KANSAS GAS AND ELECTRIC COMPANY

KMLNRC 84-171

Subj: Changes to FSAR Description of Quality Assurance  
Program

**WOLF CREEK GENERATING STATION  
UNIT NO. 1  
FINAL SAFETY ANALYSIS REPORT**

FIGURE 17.2-2  
KG&E ORGANIZATION FOR  
NUCLEAR OPERATIONS

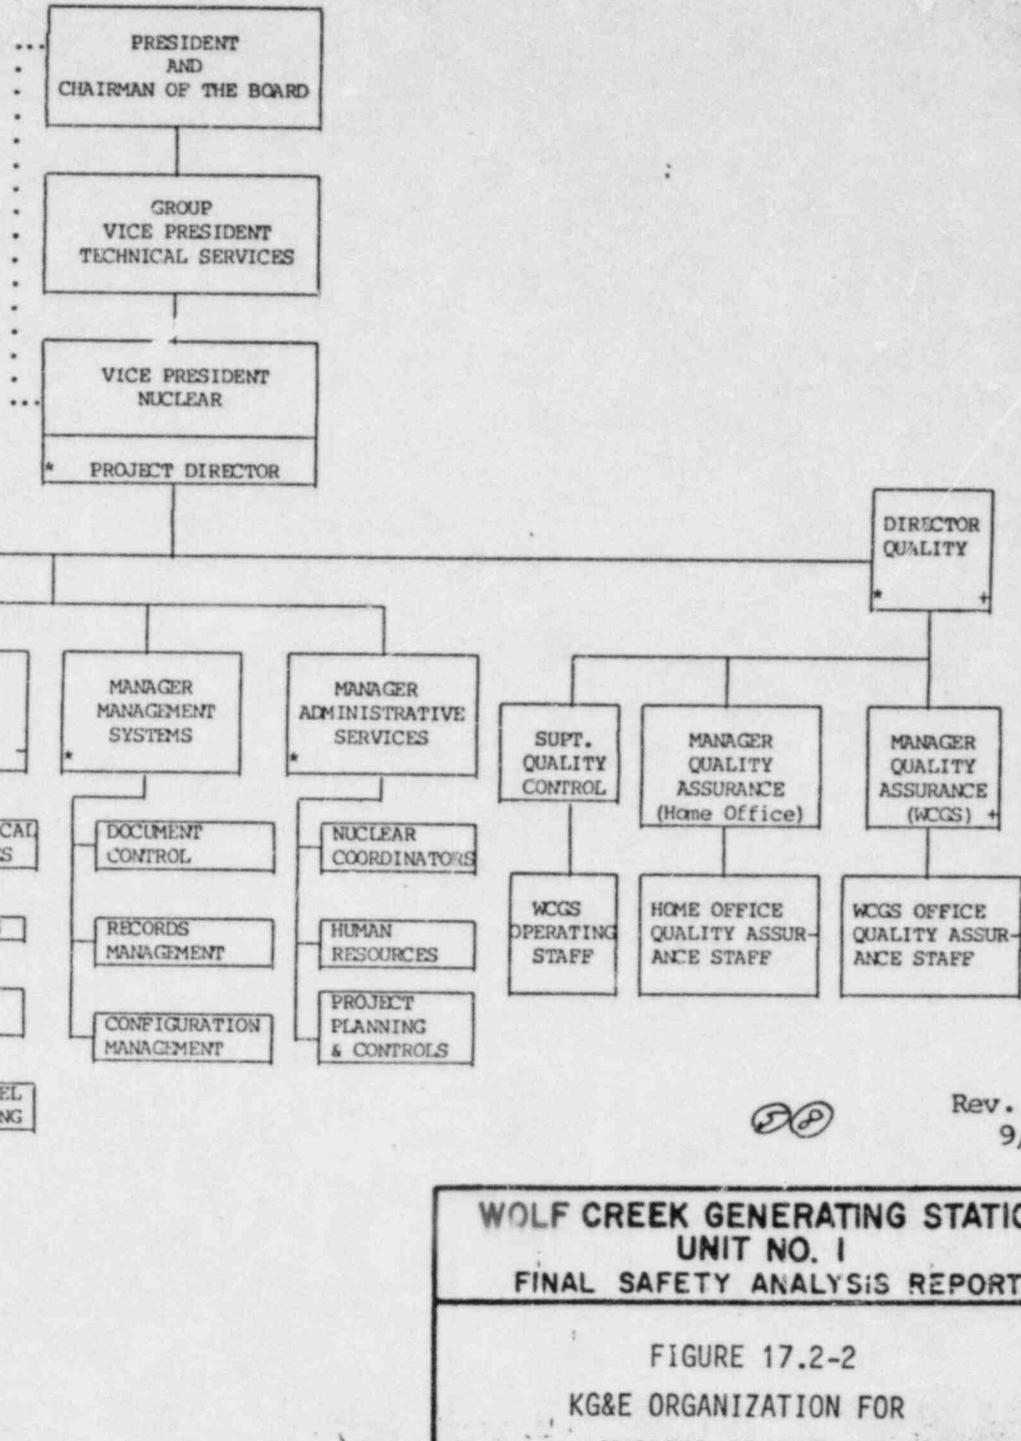
9. Reason for Change

The Director Nuclear Operations position has been filled.

Basis for Concluding that the Revised Program Satisfies  
10CFR50, Appendix B

No program change has been made.
